<b>ORDINARY MEETING</b> <b>8 SEPTEMBER 2015</b>	<b>5.3</b>
----------------------------------------------------	------------

REQUEST FOR A NEGOTIATED DECISION FOR RECONFIGURING A LOT (CODE ASSESSMENT) (1 LOT INTO 17 LOTS) – 2L OASIS DRIVE WONGA  
**Jenny Elphinstone, Senior Planning Officer, #464130**

<u>PROPOSAL:</u>	REQUEST FOR A NEGOTIATED DECISION NOTICE FOR RECONFIGURING A LOT (CODE ASSESSMENT) (1 LOT INTO 17 LOTS)
<u>APPLICANT:</u>	WROXALL INVESTMENTS PTY LTD C/- FLANAGAN CONSULTING GROUP PO BOX 5820 CAIRNS QLD 4870
<u>LOCATION OF SITE:</u>	2L OASIS DRIVE WONGA
<u>PROPERTY:</u>	LOT 2 ON SP259953
<u>LOCALITY:</u>	COASTAL SUBURBS
<u>PLANNING AREA:</u>	TOURIST AND RESIDENTIAL
<u>PLANNING SCHEME:</u>	DOUGLAS SHIRE PLANNING SCHEME 2008
<u>REFERRAL AGENCIES:</u>	NOT APPLICABLE
<u>NUMBER OF SUBMITTERS:</u>	NOT APPLICABLE
<u>STATUTORY ASSESSMENT DEADLINE:</u>	NOT LIMITED
<u>APPLICATION DATE:</u>	10 DECEMBER 2015 (ORIGINAL APPLICATION) 10 JUNE 2015 (REQUEST FOR A NEGOTIATED DECISION)
<u>APPENDIX:</u>	<ol style="list-style-type: none"> <li>1. DECISION NOTICE</li> <li>2. INFRASTRUCTURE CHARGES NOTICE</li> </ol>

Wendy Py Lee  
 Wonga Beach Subdivision  
 Drainage Details / Earthworks Plan  
 3969-SK06

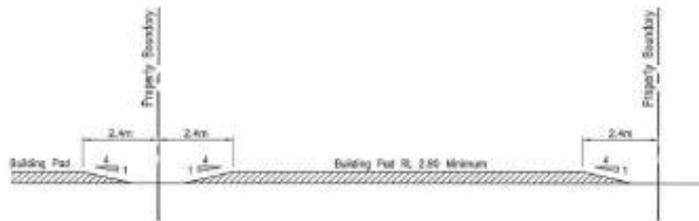
10. The concept for excavation and earthworks as detailed on FCG Sketch 3969-SK05 and SK06 is generally approved subject to compliance with the on-site disposal and drainage conditions and subject to the following amendments:
- The earthworks fill zones are to be continuous across the boundaries of lots to avoid localised low points between properties;
  - The rear of allotments are to be graded evenly in accordance with the concepts shown on FCG Sketch 3969-SK05 to ensure that they remain free draining throughout the property and through to the

- c. ~~The nominated fill level of 2.9m is to be increased to 4.04m AHD level unless otherwise approved by Council. Any reduction below 4.04m AHD must be supported by a further study, to the satisfaction of Council, to a lower level than 4.04 but no lower than 3.54m AHD. Any reduction below 4.04m AHD must utilise at least a 0.3 Sea Level Rise (SLR) and increase in intensity of cyclone action.~~

The nominated fill level of 2.9m is to be increased to provide immunity to the 1% AEP stormtide event unless otherwise approved by Council. The Cairns BMT-WMB Cairns Region Storm Tide Inundation Study, Final Report and Mapping January 2013 (Council document reference D# 462510) identified the 1% AEP stormtide event as 4.04 metres AHD having regard to a 0.8m sea level rise and intensity of cyclonic action.

The Applicant's submitted DHI Water and Environment Pty Ltd hydrodynamic analysis dated 9 June 2015 (Council document reference D#457391) utilised 0.3m AHD sea level rise and intensity of cyclonic action. The DHI hydrodynamic analysis is acceptable only where a 0.8m sea level rise is utilised and an amended study is required to be submitted to the satisfaction of the Chief Executive Officer.

Any reduction below a 0.8m sea level rise must be supported by an appropriate study that deals with sea level rise and intensity of cyclonic action to be approved by Council.
